Hi-Fi Products
Service Bulletin

Model: DTC-59ES/690

No. 358

Subject: Intermittent Audio, Mechanism Wrinkles Tape

Figure 2

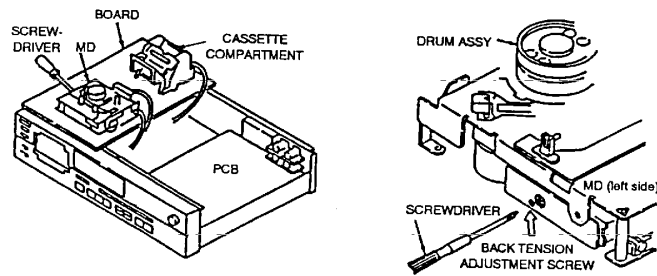
1. Remove the mechanical deck and the cassette compartment from the unit and separate the two assemblies. Place the two assemblies on a board without disconnecting any electrical connections (see Figure 2).
2. Put the unit in the test mode, insert a TW-7131 torque test tape (P/N 8-909-708-71) and press the forward button on the unit.
3. Adjust the back tension by slightly turning the adjustment screw located on the left side of the mechanism.
4. Changing modes once or twice (ie. PLAY - PAUSE - PLAY) during the procedure ensures an accurate adjustment. The back tension should be adjusted to 5.0 g/cm to 6.0 g/cm.
5. Check that this value remains steady for one revolution of the torque meter. This adjustment should be completed before one minute has elapsed as the torque will begin to vary when the plunger begins to heat up.
